## TFJ NOVI JSP21-22

Consideration of TFJ Novi at the request of Broder and Sachse Real Estate for approval of the Preliminary Site Plan and Stormwater Management Plan. The subject property contains 1.16 acres and is located in Section 36, on the east side of Haggerty Road, north of Eight Mile Road. The applicant is proposing to demolish a former Big Boy Restaurant at the corner of Eight Mile Road and Haggerty Road and redevelop the site in order to build an 8,488 square foot building to be used by Tapper's Fine Jewelry and Rolex.

# PLAN REVIEW CENTER REPORT

July 20, 2021  
**Tappers Jewelry Store**  
**Preliminary Site Plan - Landscaping**

SHEET NO:  
**A-2.0**

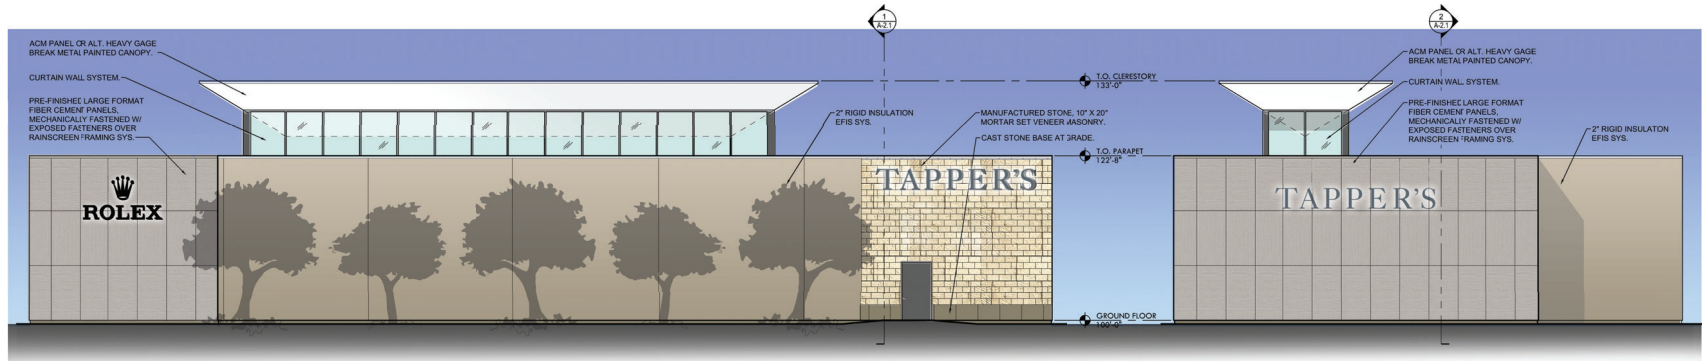
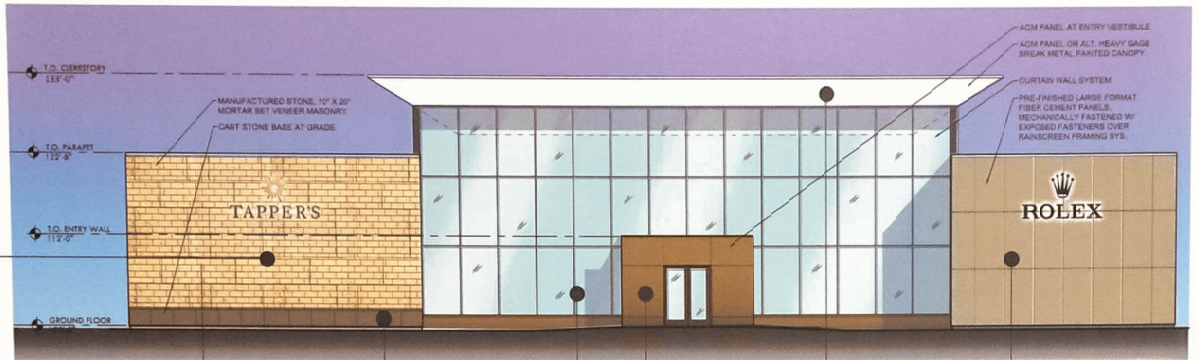
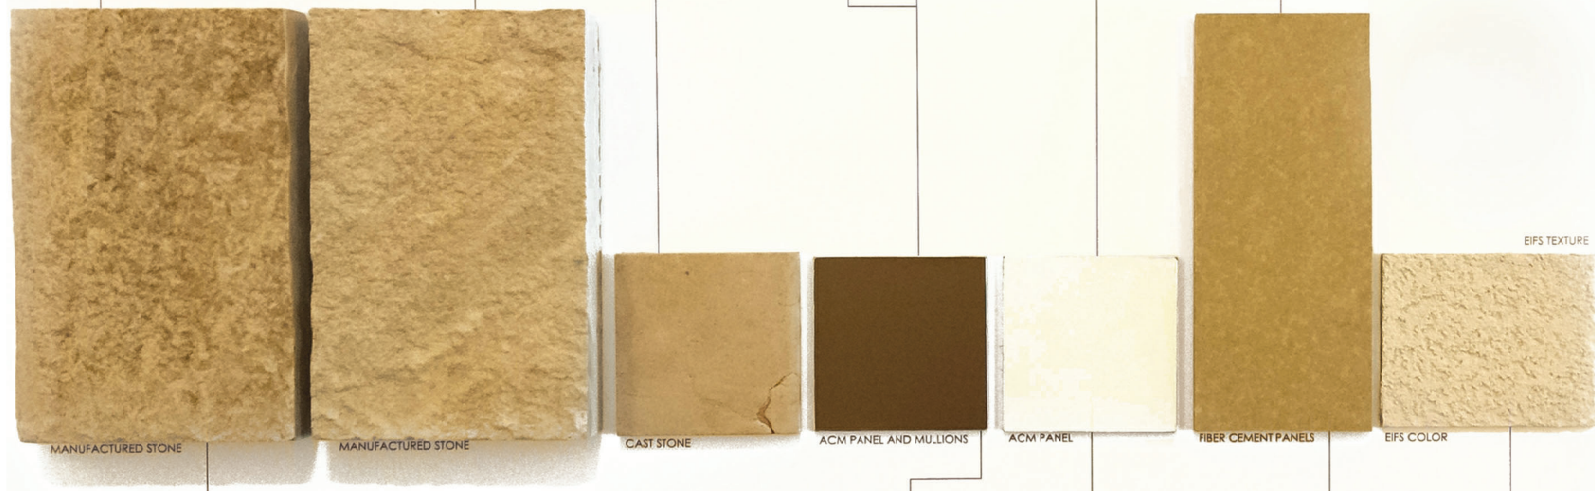
The following Façade Review is based on the revised drawings prepared by Ken Nisch Architects, dated 7/12/21. The percentages of materials for each façade are shown on the table below. The maximum and minimum percentages required by the Ordinance Section 5.15 are shown in the right-hand column. Materials in non-compliance are highlighted in bold. A material sample board was provided via photographs on sheet A-3.0.
